STATE OF NORTH CAROLINA DEPARTMENT OF TRANSPORTATION

March 24, 2010

SUBJECT:

Subsurface Drainage

ORIGINAL BY: STD.815.02 DATE:	
MODIFIED BY: T.SPELL DATE: 11-10	-09
CHECKED BY: DATE:	
FILE SPEC.: s:tspell/details/815d02.dgn

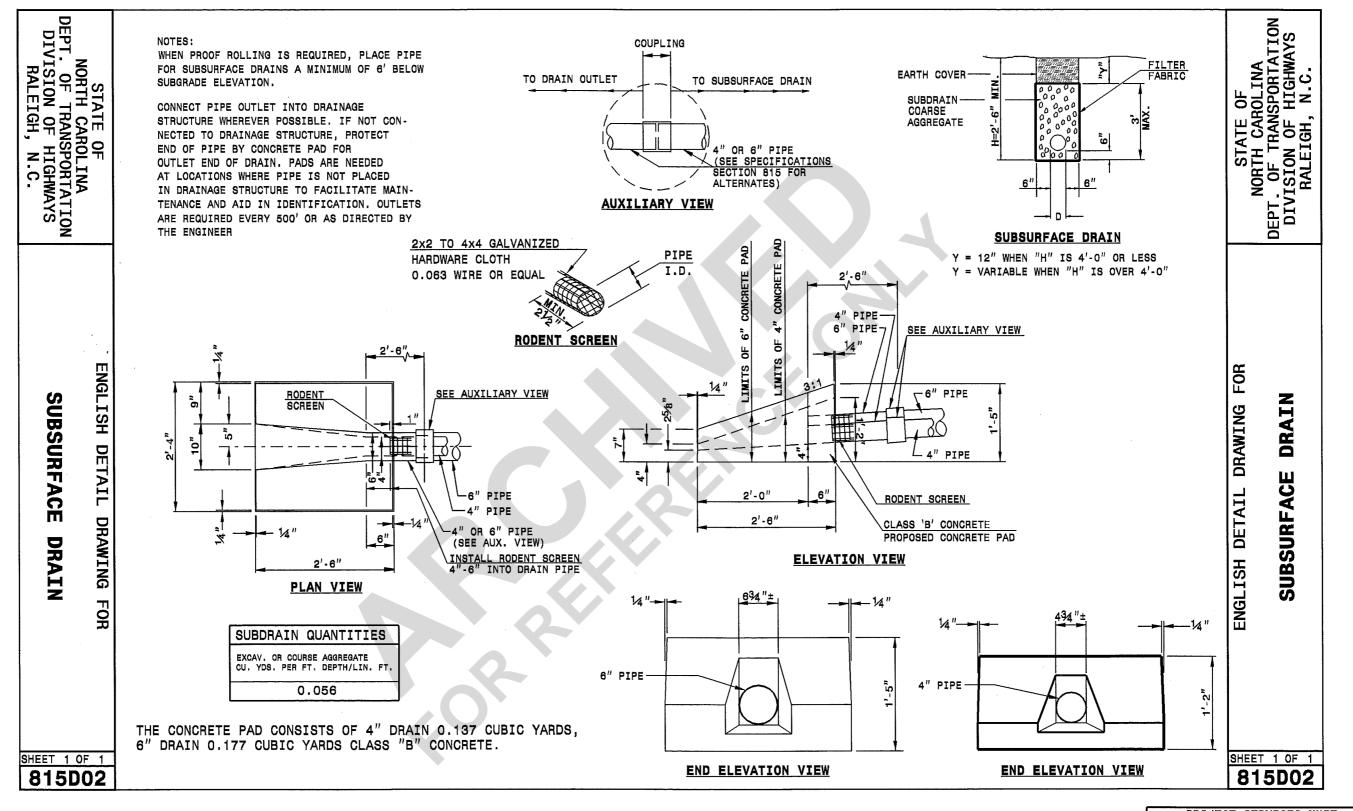
The Contract Standards and Development and Geotechnical Engineering Units have completed the development of a new special provision entitled "Subsurface Drainage" and a new detail drawing entitled "Subsurface Drain" to be effective with the July 20, 2010 letting. These new items have been attached to this memorandum for your reference. This new provision and detail drawing include changes to the pay items and plans. The purpose of this memorandum is to inform groups involved in plan and quantity estimate preparation about how to handle these changes.

The new subsurface drain detail drawing can be requested from the Standards Squad Leader, Joel Howerton, P.E. when the geotechnical recommendations recommend subsurface drains. In addition, we recommend revising the Roadway Design Manual to reflect this memorandum. If there are any questions regarding this memorandum, please contact Scott Hidden, P.E. of the Geotechnical Engineering Unit at (919) 250-4088.
